TECHNICAL NOTE

Job Name: Great Brighams Mead – Serviced Apartments
Job No: 332511484
Note No: TR/TN001
Date: 04/10/23
Prepared By: EF
Subject: Response to RBC Highways Comments

Re: Consultation on Planning Application

Application Number: 230745

DRAWING NAME:
PROPOSED GROUND PLAN

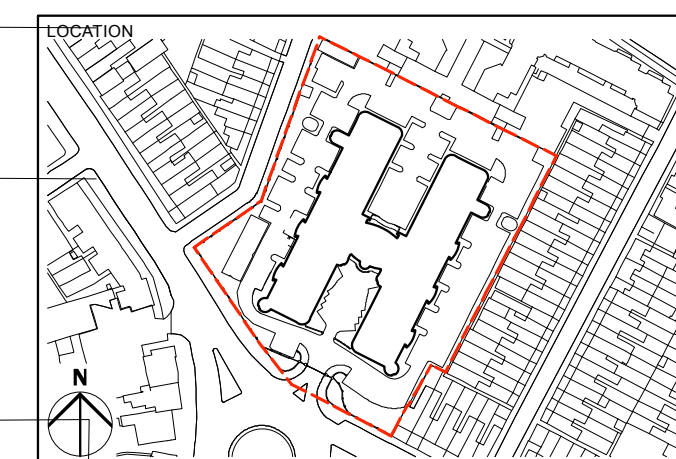
- 2.1. **RBC Comment:** *“Clarification is required how the C1 use will be serviced as the introduction of the additional C1 facility will intensify the servicing of the site therefore information is required addressing this”*

- 2.2. *“The applicant should ensure that the refuse storage provisions comply with the Council’s Waste Management Guidance. To minimise the potential for delays to collections, the designated collection area should be large enough for all the refuse and recycling bins to be positioned ready for collection at the same time. The space in the collection area must be sufficient to enable operatives to return emptied bins to a position that does not obstruct the manoeuvring of those containers that are yet to be emptied. On site collection is proposed and a refuse pick up point has been identified towards the front of the site, however details of where the bins are stored, and the collections arrangements need to be provided.”*

- 3.1. **RBC Comment:** “The Transport statement states that there will be 15 employees per day – comprising 50% full-time staff and 50% cleaners visiting once per day. Cycle parking should be provided as per the Revised Parking Standards and Design SPD which requires covered Sheffield type stands at a ratio of 1 space per 6 staff. Applicant states that eight cycle parking spaces will be provided to the staff which is in excess of current standards. The location of the storage unit has been illustrated on plans but the number of and type of stands have not. Clarification and revised plans required.”

- 2.3. **Stantec Response:** The bin storage area has been moved since the submitted scheme to rear of building to allow for the retention of the trees to the front of the site. Dedicated storage for the C1 use has been provided adjacent to storage for the C3 units with space to accommodate 14 x 1,100 litre eurobins. The storage is large enough for all the refuse and recycling bins to be situated all in one location ready for collection at the same time. Please refer to the revised drawing provided in **Appendix B**.

- 3.2. **Stantec Response:** It is expected there will be approximately 15 employees on site per day. 8 Sheffield stands will be provided within a covered store to the west of the site adjacent to the cycle parking for the C3 units. The provision will be sufficient should any guests also travel by cycle. The details of this are illustrated on the revised plan in **Appendix B**.
